<b>8.5</b>	<b>253-257 NORMANBY ROAD, SOUTH MELBOURNE</b>
<b>LOCATION/ADDRESS:</b>	<b>253-257 NORMANBY ROAD, SOUTH MELBOURNE</b>
<b>RESPONSIBLE MANAGER:</b>	<b>GEORGE BORG, MANAGER CITY DEVELOPMENT</b>
<b>AUTHOR:</b>	<b>SIMON GUTTERIDGE, PRINCIPAL PLANNER FBURA ROSANNE MASSEY, SENIOR URBAN PLANNER</b>
<b>TRIM FILE NO.:</b>	<b>PF17/273837</b> <b>1. Plans (edit) pt 1</b> <b>2. Plans (edit) pt 2</b> <b>3. Elevations (edit)</b> <b>4. Sections</b> <b>5. Apt types - podium</b> <b>6. Apt types - tower (edit)</b> <b>7. Shadow plans pt 1</b> <b>8. Shadow plans pt 2</b> <b>9. Shadow plans pt 3</b> <b>10. Renderings pt 1</b> <b>11. Renderings pt 2</b> <b>12. Draft Conditions</b>
<b>ATTACHMENTS:</b>	
<b>WARD:</b>	Gateway Ward
<b>TRIGGER FOR DETERMINATION BY COUNCIL:</b>	Use of land for Accommodation (Dwelling, Residential hotel) in the Capital City Zone
<b>APPLICATION NO:</b>	2/2017/MIN
<b>APPLICANT:</b>	SM 253 Pty Ltd c/- Urbis Pty Ltd

## **PROPOSAL**

Demolish the existing buildings and works, construct a building comprising two towers of 33 and 42 storeys height including a five level podium containing ground floor level retail and townhouse dwellings, and apartments and a 147 room Resident

#### Basement

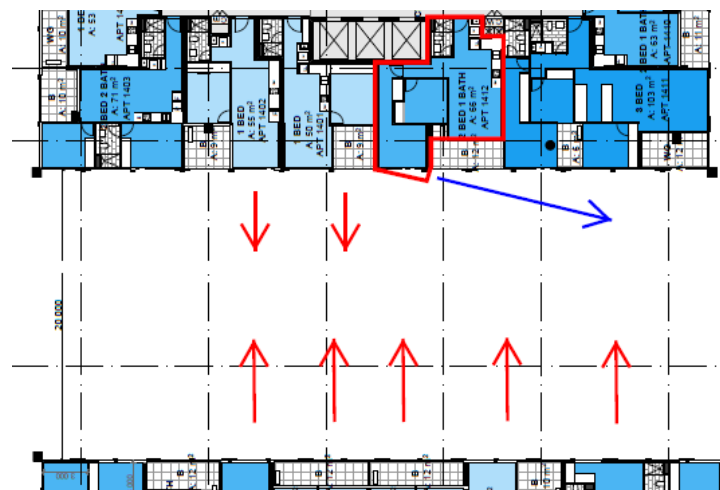
- **Bicycle storage** – The bicycle storage is spread in several areas within the basement with no clear, easy access. Ideally cycle access should be easy from ground level, with limited depth within plans and limited negotiation of narrow car ramps and aisle (that have limited visibility and limited additional safe width for passing of cycles). Consider:
  - providing a one or two combined locations
  - supporting these areas with tyre pumping / other rider support facilities
  - providing dedicated, and secure cycle ramps from ground level to these parking areas and/or –
  - a clear link from the cycle storage to the lifts that serve upper level apartments, and

- stairs that serve the retail and lower level apartments
- improved security with good passive surveillance and CCTV for bicycle storage areas.

- **Electric vehicles** – provide detail of charging facilities to be provided for electric car, bike and other vehicles.
